Contract #: 04-0120F4Cty: SF/ALA Rte: 80 PM: 13.2/13.9File #: 69.25B**QUALITY ASSURANCE -- NON-CONFORMANCE REPORT****Location:** Changxing Island, Shanghai, P.R. China**Report No:** NCR-000783**Prime Contractor:** American Bridge/Fluor Enterprises, a JV**Date:** 02-Jul-2010**Submitting Contractor:** Zhenhua Port Machinery Company, Ltd (ZPMC), Changxing Island**NCR #:** ZPMC-0745**Type of problem:**

Reference Description: Missed MT indication: Cross Bracing gusset plate to Doubler**Description of Non-Conformance:**

NON-CONFORMANCE REPORT TRANSMITTAL

Job Name: SAS Superstructure
Document No: 05.03.06-000740

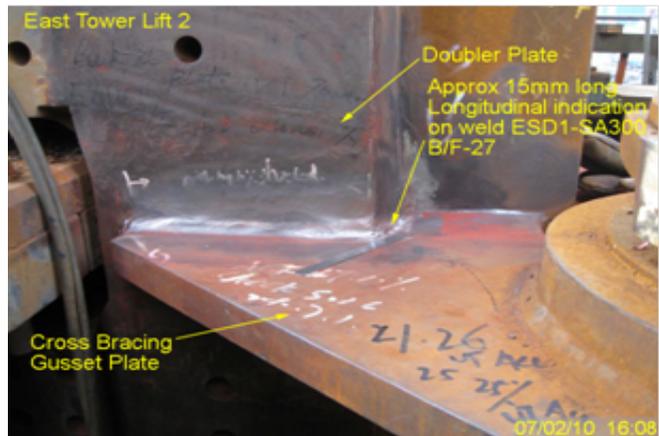
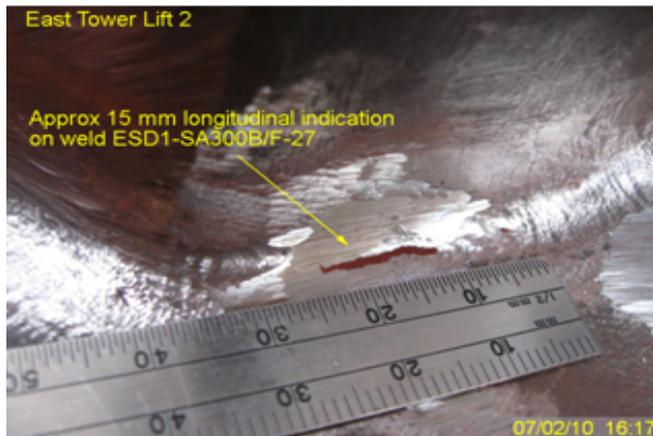
During Magnetic Particle Testing (MT) review of welds on East Tower Lift 2, Quality Assurance Inspector (QA) discovered the following issues:

- One Longitudinal crack indication measuring approximately 15mm in length.
- The member is identified as Cross Bracing gusset plate to Doubler plate
- The weld is identified as ESD1-SA300B/F-27.
- The weld is a Partial Joint Penetration (PJP) weld, joining the Cross Bracing gusset plate to Doubler plate.
- The member is Seismic Performance critical Member (SPCM).
- The member is located in Tower Trial Assembly.

The Notice of Witness Inspection Number (NWIT) is 06106. The indication is located within the area that has been previously tested and accepted by ZPMC Quality Control (QC) personnel. As per the contract documents, ZPMC's QC personnel are required to perform 100% MT inspection of this weld.

Reference Resolution: ZPMC has repaired the indications missed and is submitting the CWR and NDT used at the time.

ZPMC has repaired the indications missed and is submitting the CWR and NDT used at the time. ZPMC has discussed this issue with both their inspectors and productions staff to eliminate the indications during production and also after during inspection. Based on this ZPMC requests closure of this NCR.

Reference Description: Missed MT indication: Cross Bracing gusset plate to Doubler

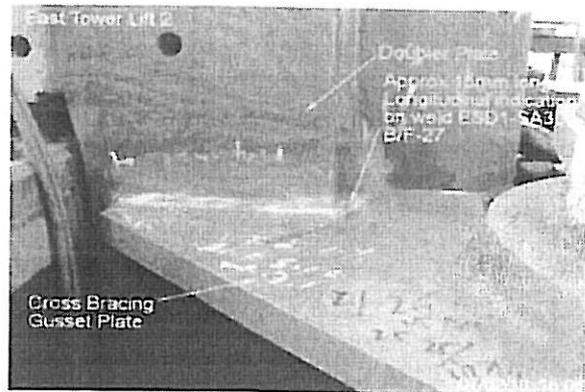
During Magnetic Particle Testing (MT) review of welds on East Tower Lift 2, Quality Assurance Inspector (QA) discovered the following issues:

- One Longitudinal crack indication measuring approximately 15mm in length.
- The member is identified as Cross Bracing gusset plate to Doubler plate
- The weld is identified as ESD1-SA300B/F-27.
- The weld is a Partial Joint Penetration (PJP) weld, joining the Cross Bracing gusset plate to Doubler plate.

-The member is Seismic Performance critical Member (SPCM).

-The member is located in Tower Trial Assembly.

The Notice of Witness Inspection Number (NWIT) is 06106. The indication is located within the area that has been previously tested and accepted by ZPMC Quality Control (QC) personnel. As per the contract documents, ZPMC's QC personnel are required to perform 100% MT inspection of this weld.

| 项目名称 Project Name: | 美国海湾大桥 SFOBB | 部件图号 Drawing No.: | ESD1-SA300B/F | 报告编号 Report No.: | T-CWR664 |

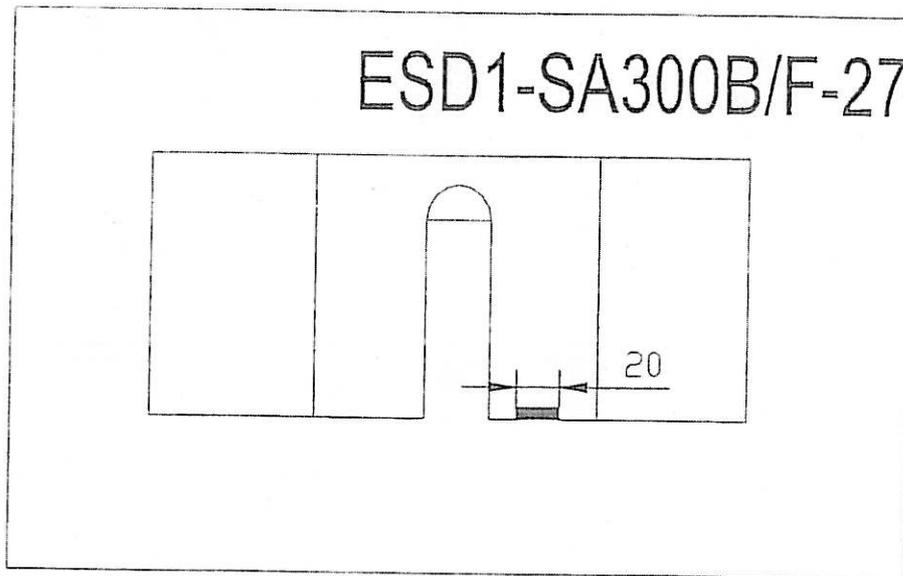
东二吊53米十字撑补板焊缝ESD1-SA300B/F-27在加州报验MT时发现长度20MM的裂纹, 现需返修。

The crack was found at east tower 2nd lifting strut plate weld (ESD1-SA300B/F-27), and need to repair.

1. 火焰加热时, 水汽没有完全的去除或者这个区域预热不够;
1. Moisture wasn't completely removed during drying operation (preheating) or the area wasn't preheated sufficiently.

1. QC /CWI shall monitor and direct all gouging, grinding and welding during the repair procedure.
2. Remove defects by gouging and /or grinding. If gouging is used, preheat the repair area to a minimum temperature of 65°C.
3. Prepare excavation according to the approved repair WPS.
4. Grind the repair area to a smooth and shiny surface.
5. Verify that no defects are present by VT and MT prior to weiding.
6. Clean excavation of all loose debris and MT powder.
7. Weld according to the approved WPS.
8. Preheat and maintain interpass temperature control in accordance to the approved WPS.
9. QC shall ensure all slag has been removed prior to the deposition of the next pass.
10. Blend the weld repaired areas into the adjacent weld or base metal by grinding.
11. Perform VT, MT and UT inspection to the repaired areas.

1. QC shall verify sufficient preheat has been applied, to remove moisture, prior to welding.

Reference Description: Missed MT indication

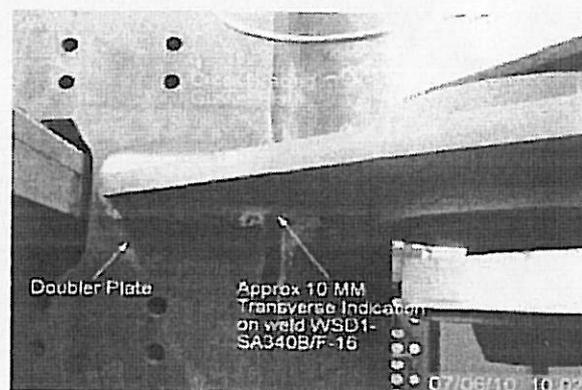
During Magnetic Particle Testing (MT) review of welds on West Tower Lift 2, Caltrans Quality Assurance Inspector (QA) discovered the following issues:

-One transverse indication (crack) measuring approximately 10mm in length in PJP weld between gusset plate and doubler plate

-The weld is identified as WSD1-SA340B/F-16.

The Notice of Witness Inspection Number (NWIT) is #06134. The indication is located within the area that has been previously tested and accepted by ZPMC Quality Control (QC) personnel. As per Contract, 100% MT inspection is required for this weld.

| 项目名称 Project Name: | 美国海湾大桥 SFOBB | 部件图号 Drawing No.: | WSD1-SA340B/F | 报告编号 Report No.: | T-CWR669 |

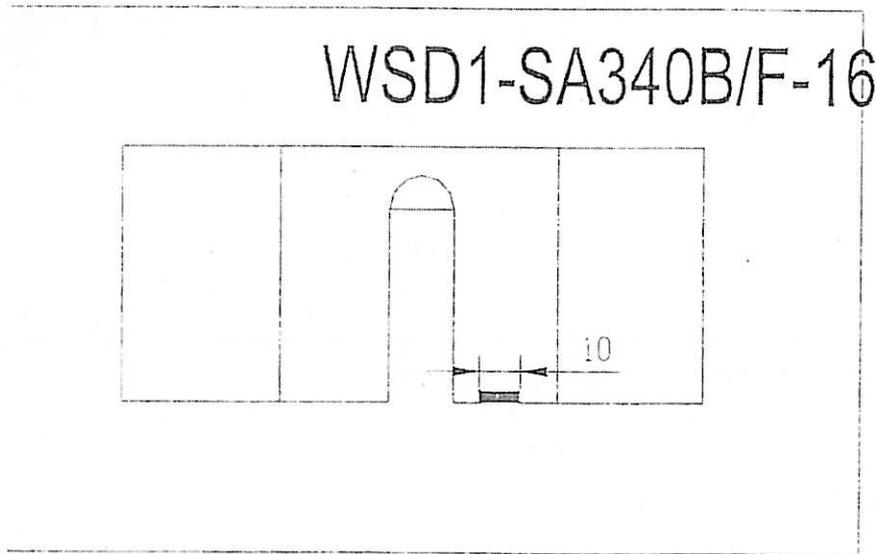
西二吊53米十字撑补板焊缝WSD1-SA340B/F-16在加州报验MT时发现长度10MM的裂纹, 现需返修。

The crack was found at west tower 2nd lifting 53m strut plate weld WSD1-SA340B/F-16, 10mm in length, and needed to repair.

1. 火焰加热时, 水汽没有完全的去掉或者这个区域预热不够;
1. Moisture wasn't completely removed during drying operation (preheating) or the area wasn't preheated sufficiently

1. QC /CWI shall monitor and direct all gouging, grinding and welding during the repair procedure.
2. Remove defects by gouging and /or grinding. If gouging is used, preheat the repair area to a minimum temperature of 65°C.
3. Prepare excavation according to the approved repair WPS.
4. Grind the repair area to a smooth and shiny surface.
5. Verify that no defects are present by VT and MT prior to weiding.
6. Clean excavation of all loose debris and MT powder.
7. Weld according to the approved WPS.
8. Preheat and maintain interpass temperature control in accordance to the approved WPS.
9. QC shall ensure all slag has been removed prior to the deposition of the next pass.
10. Blend the weld repaired areas into the adjacent weld or base metal by grinding.
11. Perform VT, MT and UT inspection to the repaired areas.

1. QC shall verify sufficient preheat has been applied, to remove moisture, prior to welding.
